DONALD C. COOK NUCLEAR PLANT, UNIT NO. 1

AMENDMENT TO FACILITY OPERATING LICENSE

Amendment No. 109
License No. DPR-58

SAFETY EVALUATION BY THE OFFICE OF NUCLEAR REACTOR REGULATION
RELATED TO AMENDMENT NO. 109 TO FACILITY OPERATING LICENSE NO. DPR-58

FIGURE 3.2-4

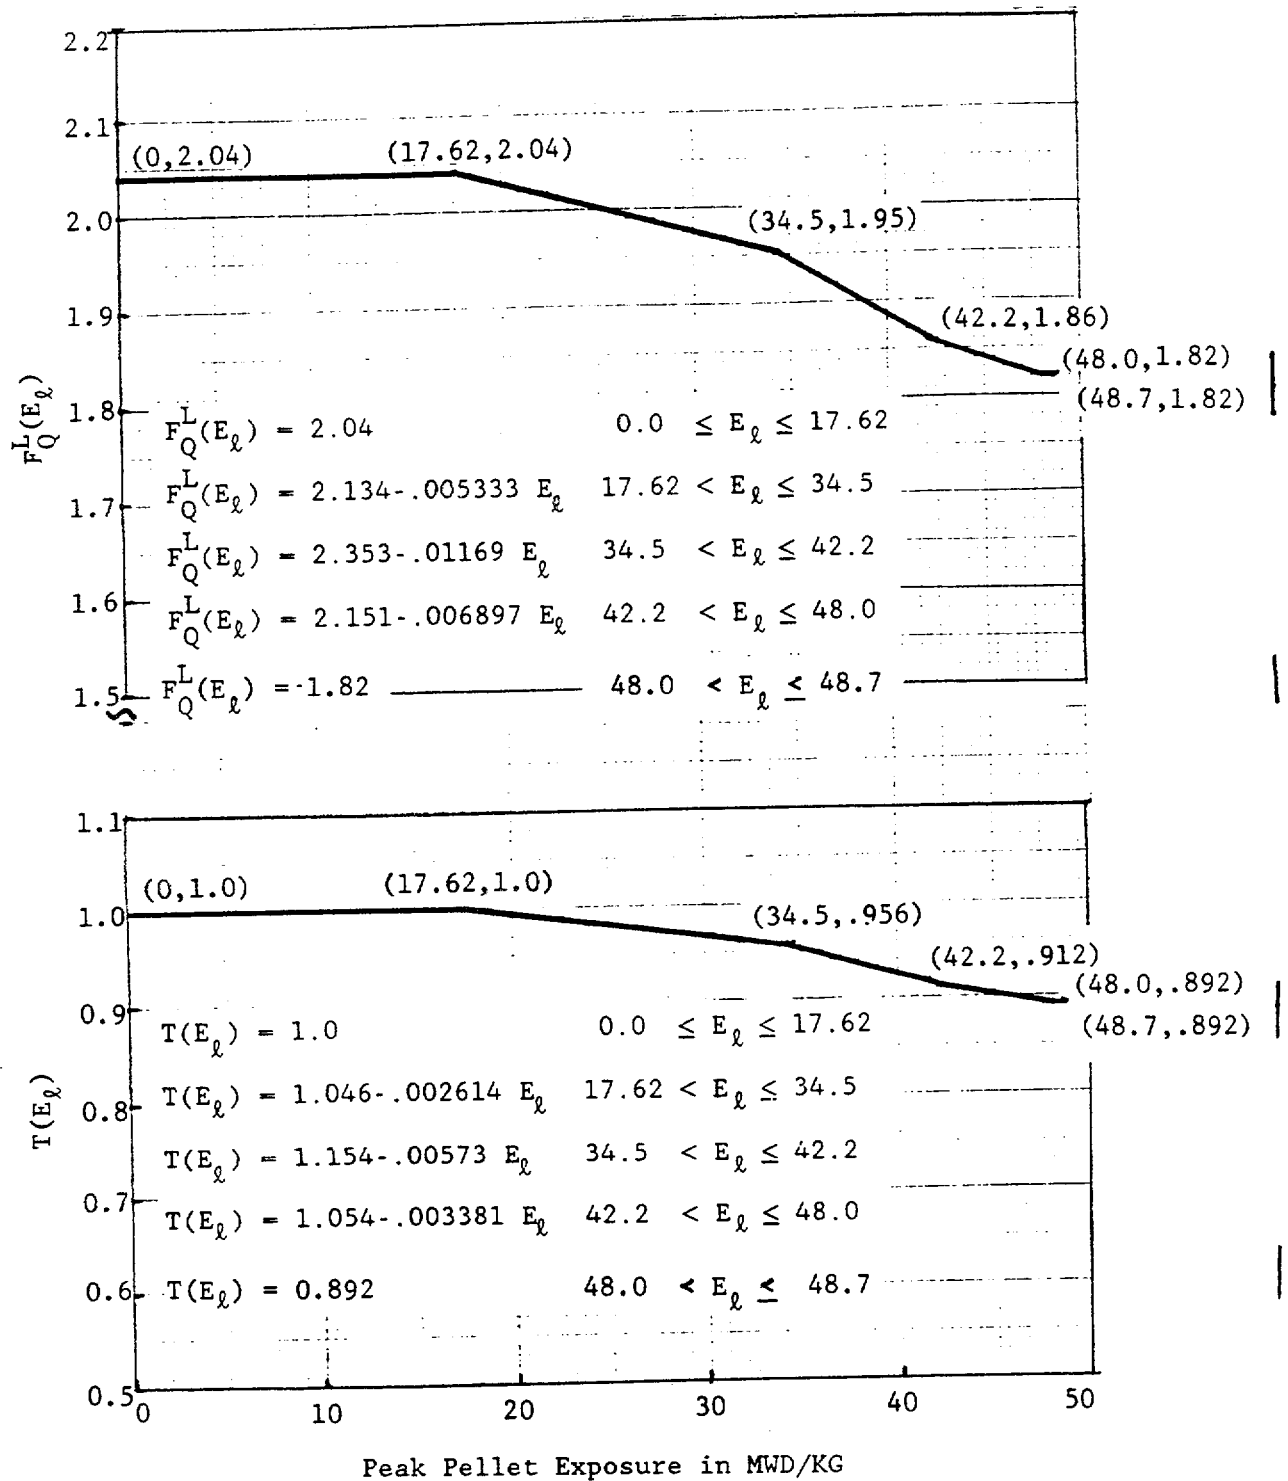
Specifically, the change to Technical Specification Figure 3.2-4 on page 3/4 2-23 concerning the exposure-dependent peaking factor limit $F_Q^L(E_1)$ shows a constant value of 1.82 from 48,000 MWd/MTU to 51,000 MWd/MTU peak pellet. The staff has accepted this value previously. However, the applicable burnup limit should be up to 48,700 MWd/MTU instead of 51,000 MWd/MTU as described in Section 3. The normalized $F_Q^L(E_1)$, $T(E_1)$, which is also contained in Figure 3.2-4, should be also made applicable up to 48,700 MWd/MTU peak pellet.

The preceding sections have shown the acceptability of the extension of the peak pellet burnup in ANF fuel from 48,000 MWd/MTU to 48,700 MWd/MTU based on the evaluation of fuel mechanical and ECCS analyses. The staff reviewed each of the Technical Specification changes, which are the result of the burnup extension, and find that they appropriately reflect these analyses and are, therefore, acceptable.

The staff has reviewed the proposed changes to Cook 1 Technical Specifications to extend the burnup limit beyond 48,000 MWd/MTU peak pellet and concludes that the proposed changes are acceptable up to the burnup limit of 48,700 MWd/MTU peak pellet only, rather than the licensee's proposed limit of 51,000 MWd/MTU for Cycle 9.
